PR/1117/22

Record of Executive Business and Chief Executive's Order

Reg. Reference: SDZ22A/0010 **Application Date:** 04-Jul-2022
Submission Type: New Application **Registration Date:** 04-Jul-2022

Proposed Development: Kelland Homes Ltd. intends to apply for permission for development on a site area of 6.3Ha, on lands within the townland of Cappagh, Dublin 22. The proposed development is located west of the Ninth Lock Road, south of the Dublin-Cork railway line, north of Cappaghmore housing estate and Whitton Avenue, and east of an existing carpark / park & ride facility at the Clondalkin Fonthill train station and the R113 (Fonthill Road). The proposed development is located within the Clonburris Strategic Development Zone (SDZ), within the development areas of (i) Clonburris South East (i.e. CSE-S1 & CSE-S2) and (ii) part of Clonburris Urban Centre (i.e. CUC-54), as identified in the Clonburris SDZ Planning Scheme 2019. The proposed development consists of the construction of 294 no. dwellings, creche and retail / commercial unit, which are comprised of: 118 no. 2, 3 & 4 bed, 2 storey semi-detached and terraced houses, 104 no. 2 & 3 bfd duplex units accommodated in 10 no. 3 s

Figure 1 proposed layout

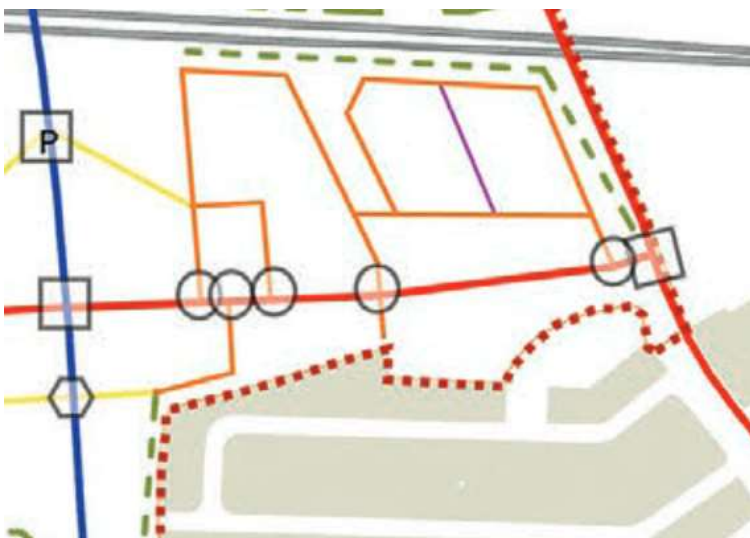
The roads layout is somewhat like the SDZ, there is a link road missing across the middle section. The number of junctions onto the main east-west link road (SDZ20A/0021) correspond to the proposed layout.

Figure 7 road cross sections.

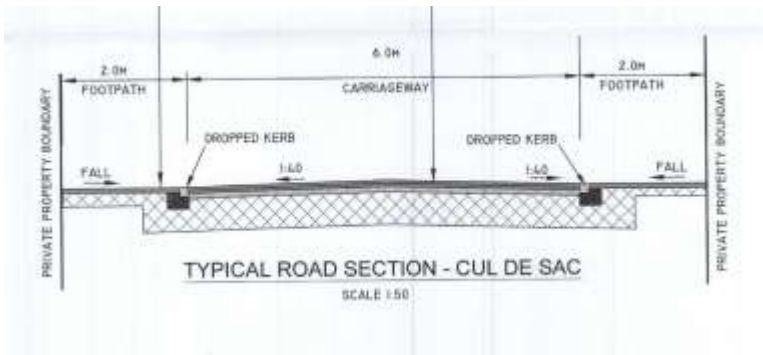
The applicant has provided road cross section details, the details refer to "Cul De Sac" they should refer to the road types identified in the road's layout plan, i.e., Homezone, Link Road etc. and should match the dimensions overall widths and parking arrangements of the road types provided in the SDZ planning scheme.

Figure 2.2.6 | Example Local Streets including hierarchy (Informal Scale)

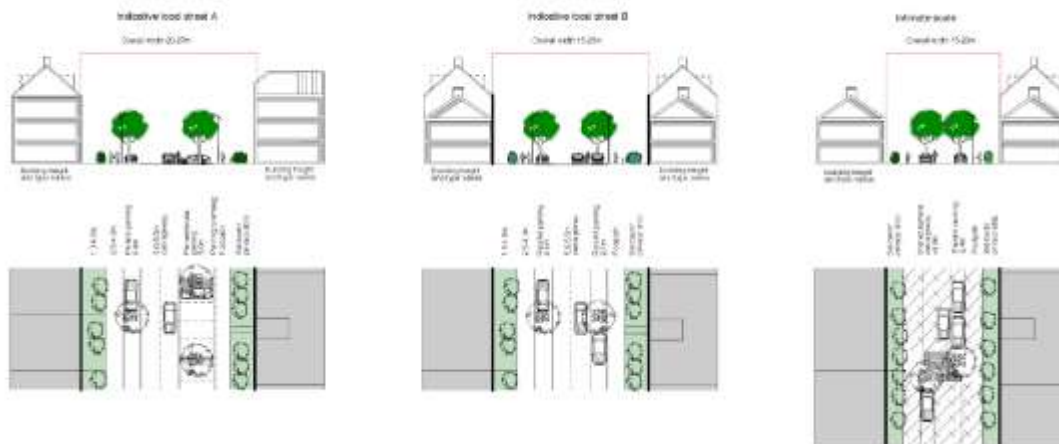
The proposed overall street widths are largely in line with the Planning Scheme. However, the Planning Authority does have concerns in relation to the allocation of space within these, particularly the Local Streets and Intimate Local Streets. Reference is made to Figure 2.2.6 in the Planning Scheme.

The Planning Authority has concerns about the level of perpendicular car parking on the local streets and the on curtilage parking in intimate local streets. The footpaths on the local street are approx. 2m when they should be 2.5-4.0m. Intimate Local Streets should be fully shared surfaces for the integrated movement of vehicles, pedestrians and cyclists in quieter residential areas. The intimate local street in the east of the site should be significantly redesigned in line with the Planning Scheme. The applicant is requested to submit revised plans indicating revised details via **additional information**. Cross sections should also be provided.
